LOCKHEED AIRCRAFT CORP.		ENGINEERING STUDY <input checked="" type="checkbox"/>		LAC - 69 *	
		CHANGE PROPOSAL <input checked="" type="checkbox"/>			
DATE 2-17-60		AFFECTS : WSPO <input type="checkbox"/>		PROJECT <input checked="" type="checkbox"/>	
NAME OF MAJOR COMPONENT FACE PIECE ASSEM.		PART OR LOWEST SUBASSEMBLY FLEX. HOSE ASSEM.		PART NO. & MODEL OR TYPE Q-237	
TITLE OF PROPOSAL : FACE PIECE HOSE AND ELECTRIC WIRING ASSEM. - REPLACEMENT					
NATURE OF PROPOSAL : <u>SEE PAGE 2</u> * THIS CHANGE PROPOSAL CANCELS AND REPLACES LAC-40 FOR CUSTOMER 1 ONLY. (LAC-40 NOW APPLIES TO CUSTOMER NO. 2 ONLY)					
REASON FOR PROPOSAL : A hazard exists upon ejection if the emergency face heat wires are connected to the face piece. This could cause the pilot's head to be pulled downward until the emergency face heat wires break or pull away from the face piece. It is possible that, when the emergency face heat wires come loose from the face piece on ejection, the attaching studs may be loosened or withdrawn from the face piece causing an oxygen leak.

NATURE OF PROPOSAL:

(Change Proposal) SEE FIG. 1 ATTACHED

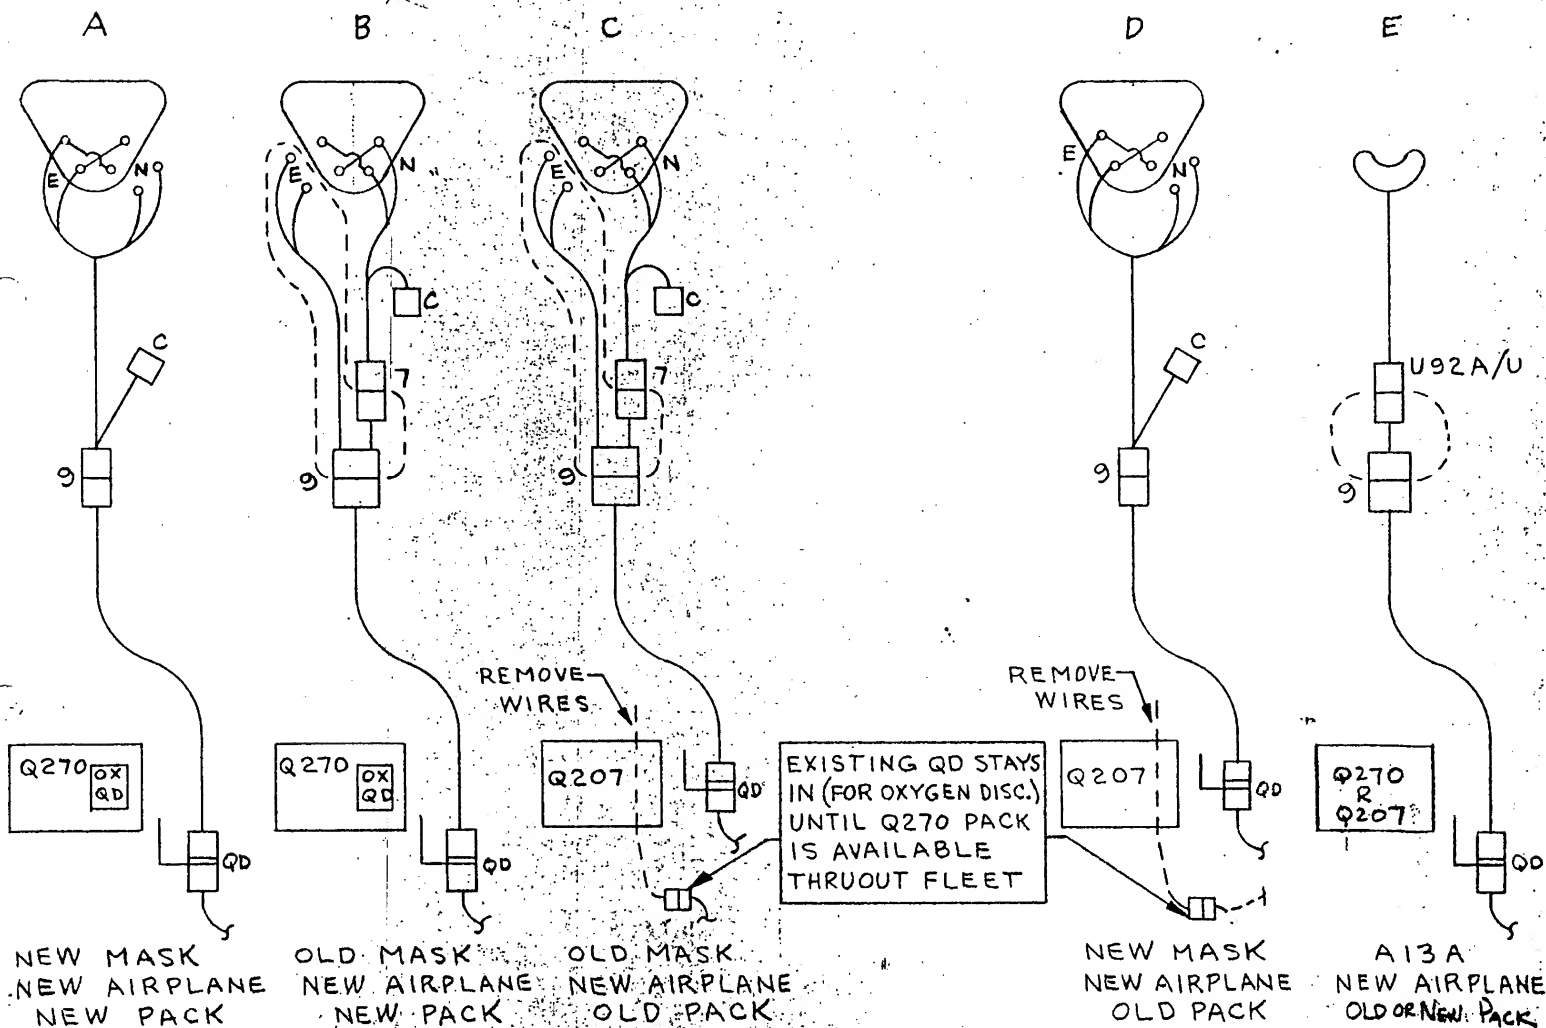
1. Provide a new face piece hose and wiring assembly which includes all required face piece wiring and has a single nine pin connector.
2. Provide a breakaway electrical connector on the side of the seat that will separate on ejection without putting a load on the face piece wires.
3. Revise aircraft circuitry to accommodate 1 and 2 above.
4. Remove all wiring to and within the Q-207 seat pack.
5. Provide wiring harness adapters that adapt the A13A mask to the system described above.

6. Provide a wiring adapter that will adapt the "old style" face piece wiring to an airplane that has had the circuitry and electrical disconnect installed.
7. Prepare and issue Service Bulletins and fabricate appropriate aircraft provisioning kits.

1. This change is compatible with the Q-270 seat pack.
2. It is not proposed to supply a wiring adapter that will adapt the new face piece wiring to an unmodified airplane, as it is felt that the airplanes will be modified before the new face piece hose and wiring is available.
3. The communications receptacle on the face piece hose will be moved to the lower end in order to use up some of the slack in the communication wires between the receptacle and the helmet.
